**Bulletin**

MODEL BENTLEY MARK VI

**MODIFICATION.****REAR BRAKE EQUALISER.**

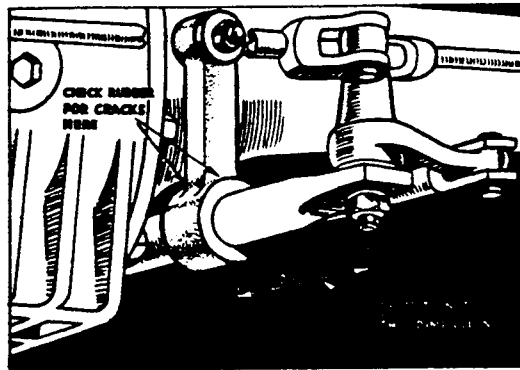
A certain number of cars were built with the rubber support of the rear brake equaliser fitted and positioned whilst in the chassis stage of production. When the body is mounted, the effect of its weight on the geometry of the rear suspension causes distortion of the support which may lead to fracture; repositioning of the support is therefore necessary in some cases.

1. Disconnect the rubber support from the axle tube and flex it backwards and forwards so as to examine for cracks in the neck at the junction with the main boss. If there are any signs of cracks, replace with a new support.
2. Check that the rear face of the main boss is 2.275 ins. from the centre of the rear brake equaliser bolt, and reposition if necessary.
3. Paint the letter 'E' on the rear face halfway down the rubber leg after examination and repositioning.

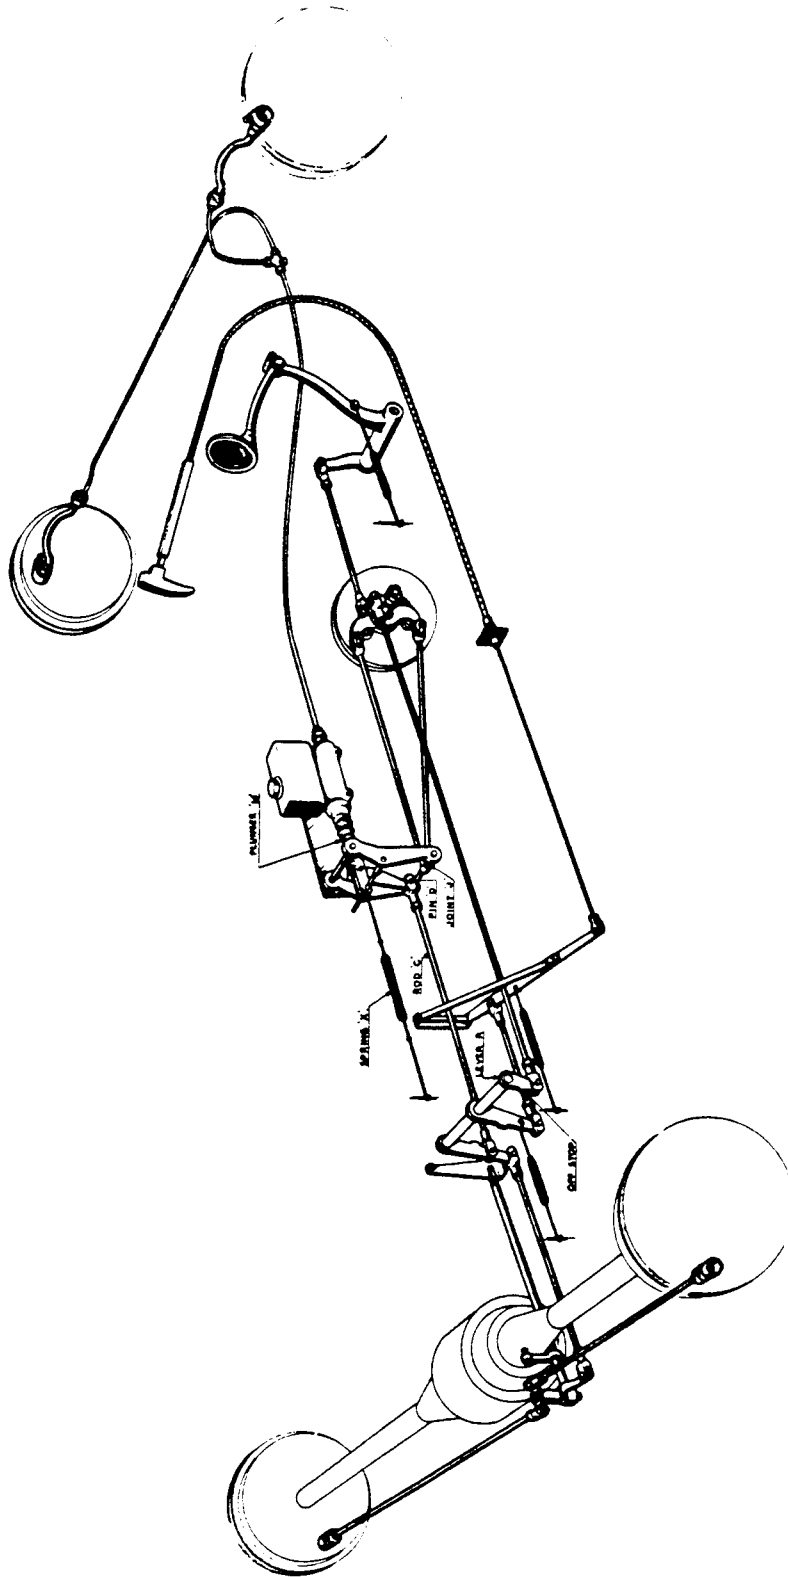
A modification is introduced to reduce a mechanical noise that can more accurately be described as a "clonk" from the brake linkage which may occur on application of the brakes.

In many cases, the origin of this noise has been traced to excessive free travel between the plunger and piston of the brake master cylinder, and adjustment of the brake linkage as described hereunder, has in certain instances effected a noticeable reduction of the noise.

1. Ensure that the rear brakes are in the OFF position and that the lever 'R' is against its OFF stop.
2. Remove the master cylinder pull-off spring 'X' and the clevis pin 'D'
3. Adjust the rod 'C' so that the joint 'J' has zero to .050" free travel before the plunger 'M' contacts the master cylinder piston.
4. Tighten the locknut on the rod 'C'. Replace the clevis pin 'D' and the master cylinder pull-off spring 'X'.

FIG. 1.

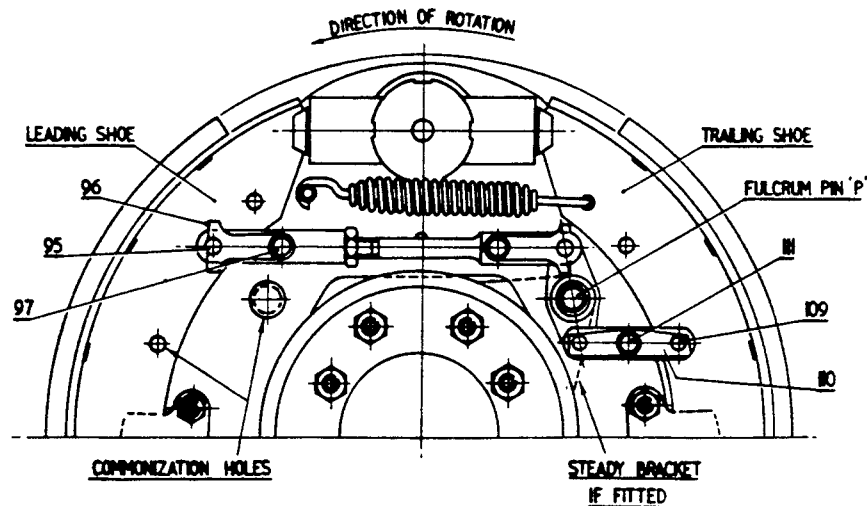
Instances have occurred in service with the Bentley Mark VI, where the front brakes have failed to release properly after application. This "Spragging" of the front brakes is due to an excessive self-servo action of the shoes, and manifests itself by a locking of the brakes even after the foot pedal has been released. In all such cases, the following modification should be carried out.

REMOVAL OF EQUAL WEAR LINKAGE (FIG.1).

- (a) Remove setscrew and spring washer (111) and the locking plate (110) and by easing the load from the pull-off spring, withdraw pin (109).
- (b) Remove setscrew and spring washer (97) and locking plate (96) and withdraw pin (95).
- (c) Remove equal wear linkage from fulcrum pin (P) complete.

FIG. 2.

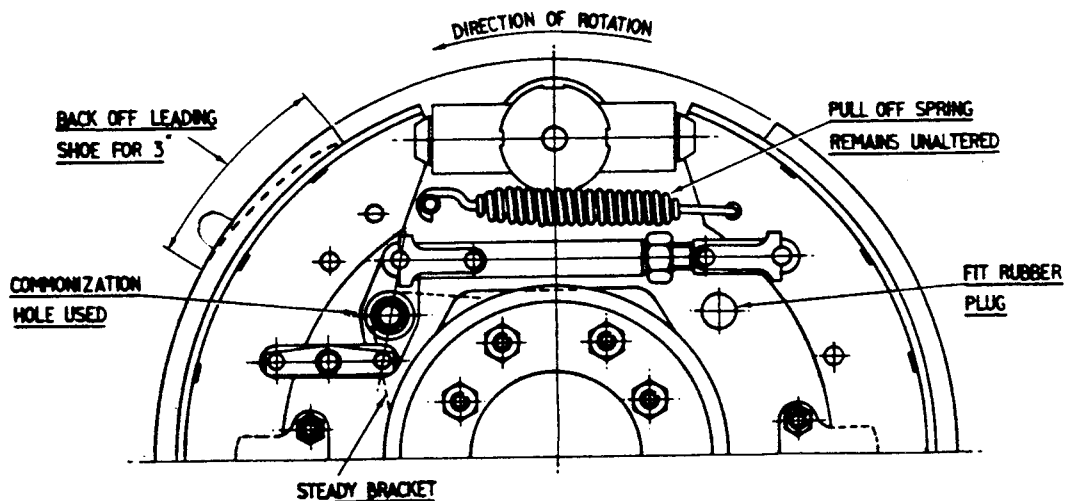
- (a) Replace the existing push rod and jaw of the equal wear assembly with the strengthened parts Nos. RG-6045/6 and nut K-4010/Z.  
NOTE: If these parts are not available, the existing push rod and jaw may be used, but should be replaced at the first opportunity.
- (b) Invert equal wear linkage assembly, and replace on fulcrum pin (P). (The short link should now be to the front of the car, and will line up with the lowest of the three top holes in the leading shoe, and the push rod will be to the rear and will line with the second hole from the top in the trailing shoe).
- (c) Replace pin (109) in the short link, locking plate (110) and the setscrew and spring washer (111).

FIG. 3.

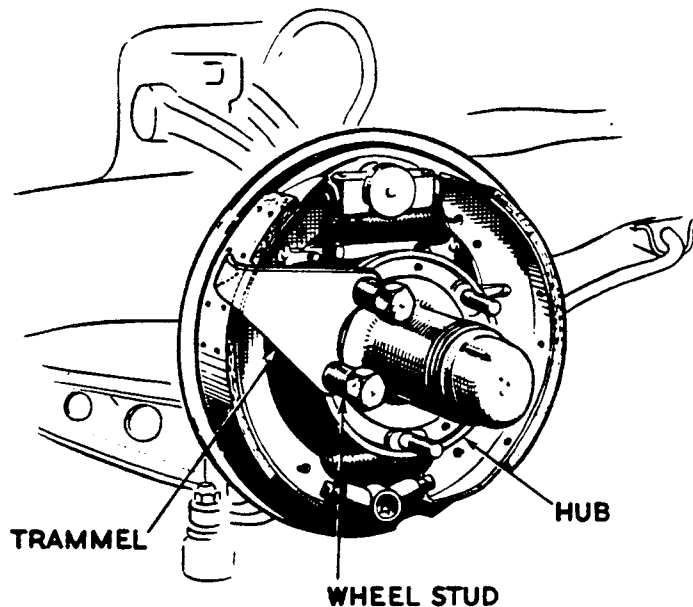
- (a) From a piece of light gauge steel, make up a trammel as shown in (FIG. 3) to fit over two of the wheel studs on the hub, and bend the pointer to touch lightly on the face of the brake linings.

FIG. 1. FITTING OF UNDERSHIELD.

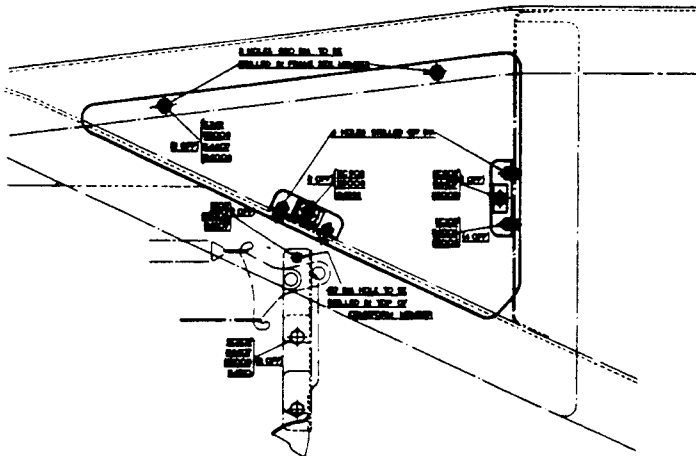
Current Bentley chassis in production are provided with protection against the possible loss in servo efficiency in wet weather, due to water finding its way on to the friction surfaces.

This protection consists of an additional undershield, which is fitted over the existing triangular gap formed between the frame side member and the cruciform member forward of the battery container, together with a vertical baffle plate located just in front of the servo unit itself.

1. Place the car over a pit, or elevate on a suitable hoist.
2. Remove the battery.
3. Remove the existing right-hand rear undershield immediately below the servo unit.
4. Offer up the new undershield from below the chassis and cover the triangular gap formed by the frame side member and cruciform member forward of the battery container. Mark off the relative positions for the two

bolt holes in the lower flange of the frame side member, also for the two supporting brackets as shown in Fig.1. Drill the two 0.250" dia. bolt holes in the frame side member.

FIG. 2. BAFFLE PLATE.

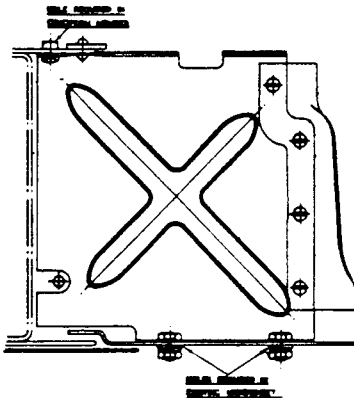
8. Fit the rubber protection piece to the baffle plate as shown in Fig.2.  
 Both the rubber and the retaining strip should be fitted on the ENGINE side of the plate, with the nuts for the securing screws on the obverse face.

FIG. 1 FITTING OF UNDER-FRAME COVER PLATE.

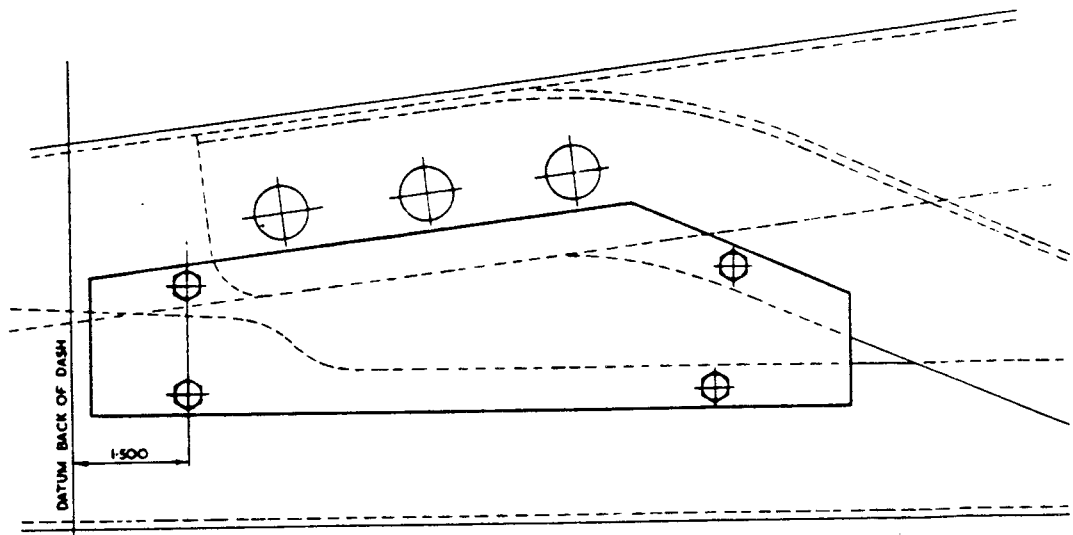
1. Fit the under-frame cover plate (RF-6209) as shown in Fig. 1.
  - a) Offer up the plate, and mark off the relative positions for the four retaining setscrews.
  - b) Drill the four holes 0.1562" dia., and then tap 2 BA (31 T.P.I. R/H).
  - c) Fit the cover plate.

FIG. 2. METHOD OF FIXING COVER PLATE OVER HAND-HOLE.

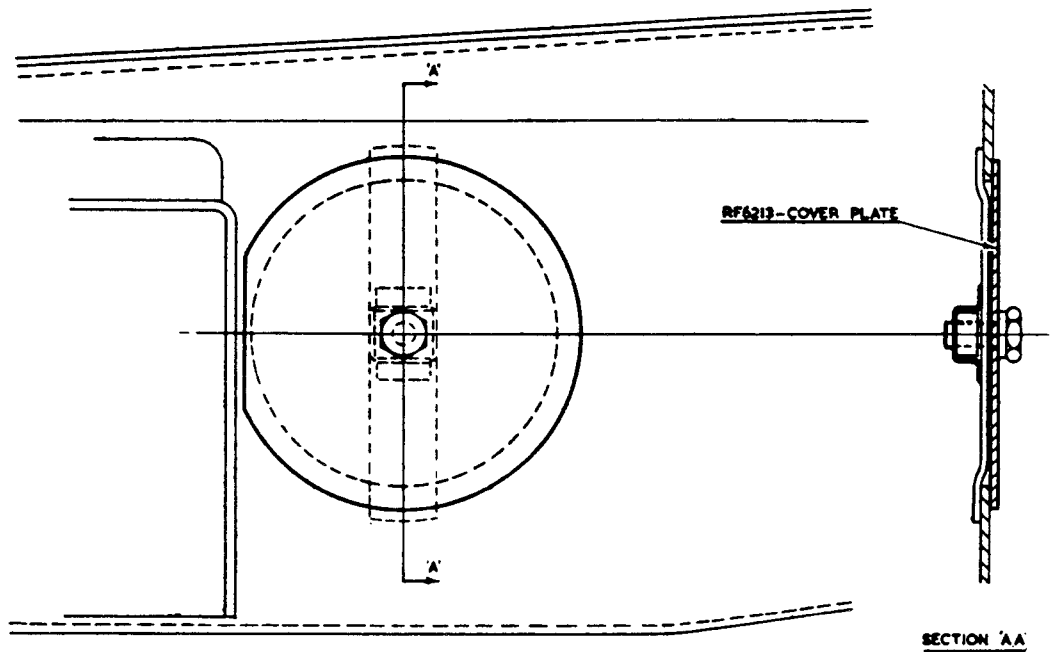
2. Fit the hand-hole cover plate (RF-6213) as shown in Fig. 2.

FIG. 1. DIAGRAM - SETTING INSTRUCTIONS - FRONT BRAKES.

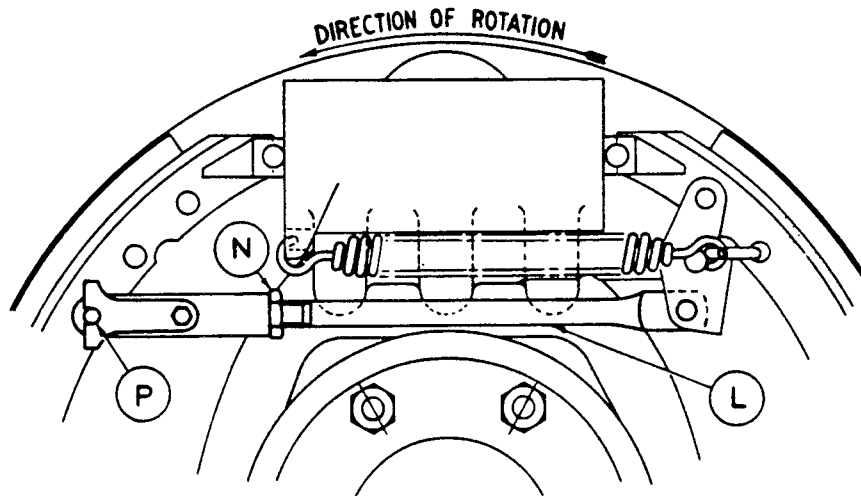
Commencing G Series, i.e. Chassis No.B-1-GT, and onwards, new front brakes are fitted which differ from the front brakes fitted to chassis prior to 'G' series, chiefly in the use of an internal hydraulic cylinder, which acts directly on the shoes in place of an external cylinder(expander) operating the shoes through a wedge mechanism.

- (i) Build up the brake complete, but do not fit the locking plate for pin P, Fig. 1, or lock the nut N. For an initial setting, the link L, should be adjusted to 7.375" (187.3 m/m) between the pin centres.

- (vi) If more than 15 "CLICKS" are obtained, remove the drum, shorten the link L, and try again. If less than 9 "CLICKS" are obtained, lengthen the link L, and try again. One complete turn of the jaw on link L, corresponds to about 3 "CLICKS" of the adjuster.

FIG. 1. MODIFIED TYPE SUPPORT

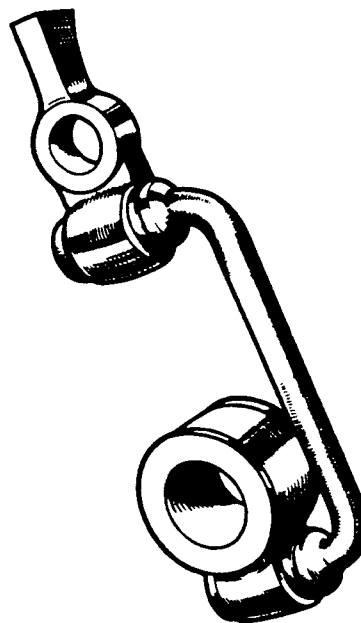
Instances have occurred where the rubber support (RG-3552) for the rear brake equaliser bar has fractured on existing Bentley Mark VI cars in service.

In order to obviate this a modified type of support assembly has now been introduced for incorporation under the following conditions:-

The modified type support assembly, illustrated in Fig.1 above, consists of a "U" shaped metal link, which is retained at either end by brackets in silentbloc bushes. The upper bracket has a radiused face to correspond with the outside of the rear axle tube, while the lower bracket carries another silentbloc bush through which the equaliser bar passes.

FIG. 2. FINAL POSITION FOR  
MODIFIED SUPPORT.

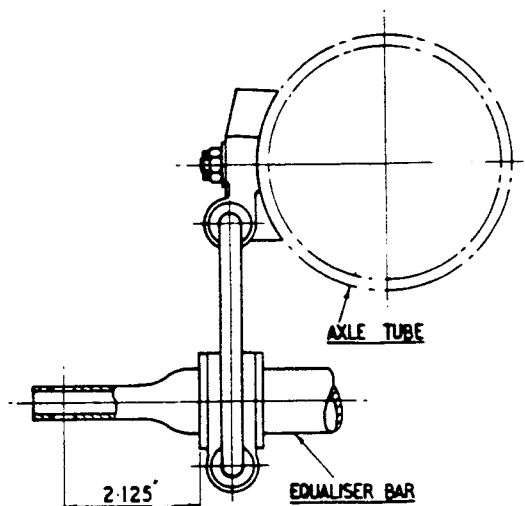
- (3) Thread on the new support assembly from the front end of the equaliser bar, and slide the assembly along the bar until the outer face of the silentbloc bush is exactly 2.125" distant from the centre of the bolt hole at the rear of the bar (See Fig. 2. above). Due to the interference between the rubber bush and the bar, it is recommended that some form of lubricant, e.g. French chalk or soap, is used to facilitate sliding the assembly along the bar.
  - (4) Fit the upper bracket to the existing stud on the axle tube, replace the existing plain washer (distance piece), and then secure by means of the thinner castellated nut provided, locking this by fitting a new 1/16" split pin. Reconnect the equaliser bar.
- NOTE:- Constructional variations in the rear axle tube may result in

FIG.1. EXPLODED VIEW OF SERVO MOTOR.

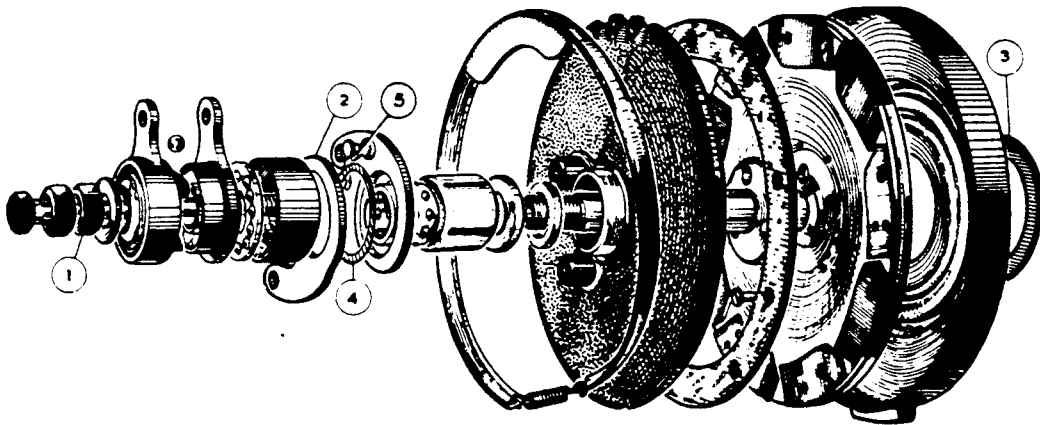
A corrugated washer, Part No. R.5037, has been developed to overcome cases of servo judder on brake application. The washer is fitted between the brake actuating levers in place of the plain washer GB.5083 and effectively damps the servo output to prevent minor fluctuations in the brake linkage from developing into judder.

1. Adjusting Nut.
2. Brake Actuating Levers.
3. Ferodo Washer (To be replaced by R.5285 if necessary).
4. Plain Washer GB.5083 (To be replaced by R.5037).
5. Spring Clip (To be removed).

On all early series cars the corrugated washer can be fitted without further modification, except from approximately B-152-UM onwards when the loading of the servo motor spring back plate was increased from 25 to 40 lbs. With the heavier load spring plate a thinner servo drive sealing washer R.5285 must be fitted in place of the Ferodo washer between the spring plate and the gearbox. This ensures that the combined end thrust of the spring plate and corrugated washer is not sufficient to prevent the brake actuating levers from returning to their off-stop on releasing the brake pedal.

FIG.2.  
A. Brake Actuating Lever. B. Servo Washer (R.5037).  
C. Feeler Gauges.

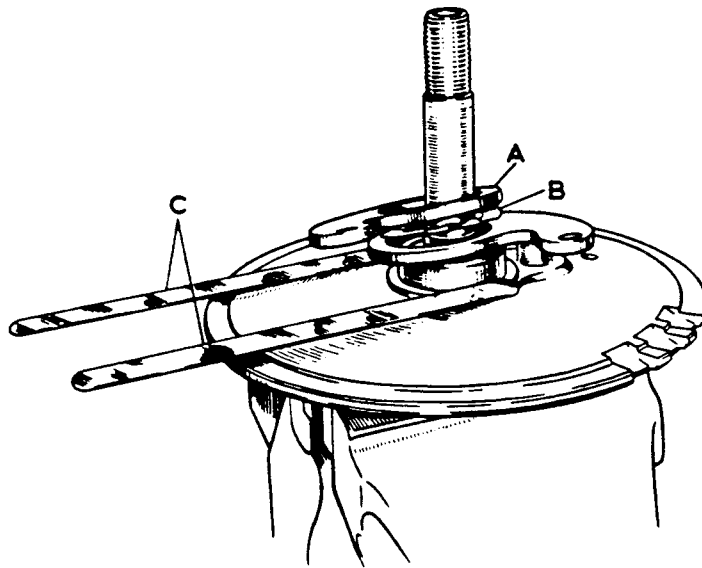
and the flange on the servo shaft. The servo is then placed in a vice as shown (Fig.2), the corrugated washer fitted into position, and the servo assembled. The adjusting nut is tightened fully home, thus compressing the corrugated washer.

FIG.3.

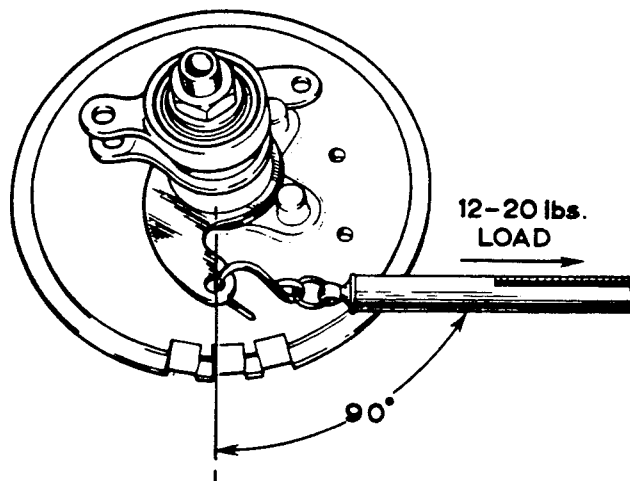
A spring balance is then attached to the brake actuating lever and the poundage figure accurately taken; this must be between 12 and 20 lbs (Fig.3).

FIG.4.

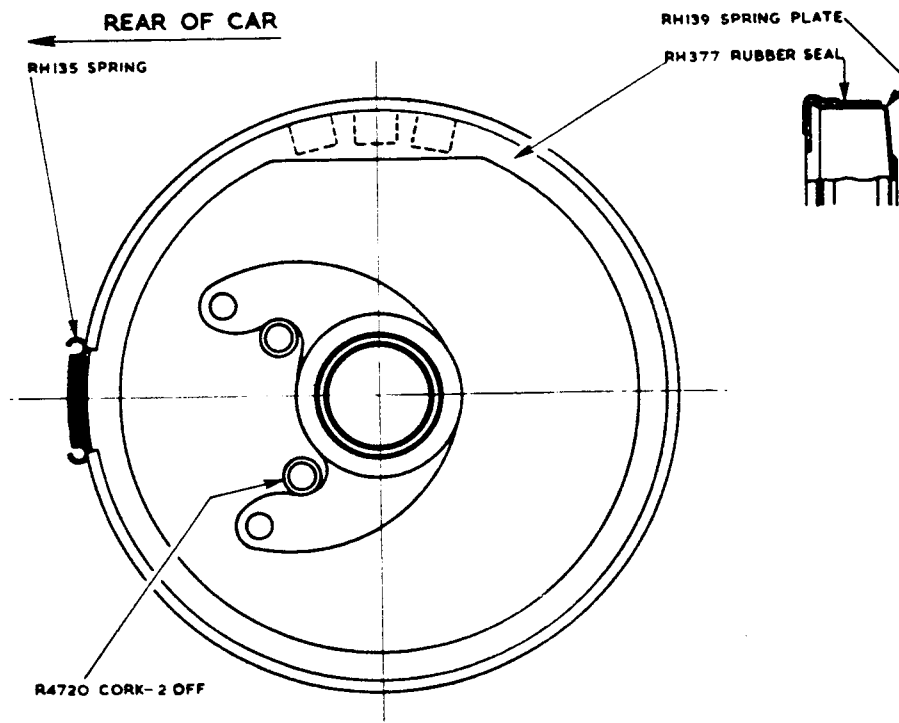
The servo spring plate, lined plate, pressure plate and servo main shaft are to be put together so that after the seal has been fitted the servo can be completely re-assembled and re-fitted, (Fig.4).

the edge of the plate, not by pulling on the outer edge of the seal as might be expected, but by pulling on the inner diameter; this prevents distortion of the outer periphery. The rest of the seal is then eased into position, still pulling on the inside diameter until the inner periphery fits closely into the spigot running around the upper face of the pressure plate. The whole seal is then to be eased into position finally and retained by the protector ring which must be fitted with the lower rate spring RH.135, otherwise it will not fit over both the seal and the pressure plate. The spring is to be positioned towards the rear of the car and not to the lowermost position as was usual. On certain servos the ends of the brake actuating lever operating pins will be open; these must be sealed with two corks (Fig.4).

Fig.2. Section-Return valve assy.  
master cylinder.

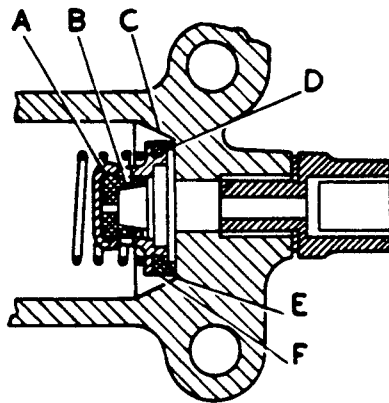
There have also been cases of ingress of air into the system due to non-sealing of the rubber valve washer 'F' Fig.2. against the face 'D' at the outlet end of the cylinder. The sealing lip 'A' Fig.1. of the rubber cups in the front brake expanders is normally held in firm contact against the bore of the expander by a residual hydraulic pressure of about 12-14 lbs. per sq/in. created by the spring loading of the return valve illustrated in Fig.2. Should this valve fail to maintain the hydraulic pressure, air may enter past the cups of the expanders owing to the comparatively low pressure exerted by the cups themselves against the bore.

Examination revealed that the primary cause of the valve washer 'F' not seating correctly, was due to the diameter of the face 'D' of the master cylinder being too small, causing the valve washer to make heavy contact with the rough un-machined tapered sides 'C' of the cylinder resulting in excessive wear and distortion of the valve washer.

- (i ) Fit a new rubber washer 'F' (RG-7043) and a rubber cup 'B' (CD-130) to the valve body 'A'. Place the coil spring on to the valve and enter into the cylinder and check that the valve assembly has a diametrical movement of approximately 0.020" (0.50 m/m) to ensure that there is sufficient clearance between the outer diameter of the valve washer at point 'E' and the cylinder.
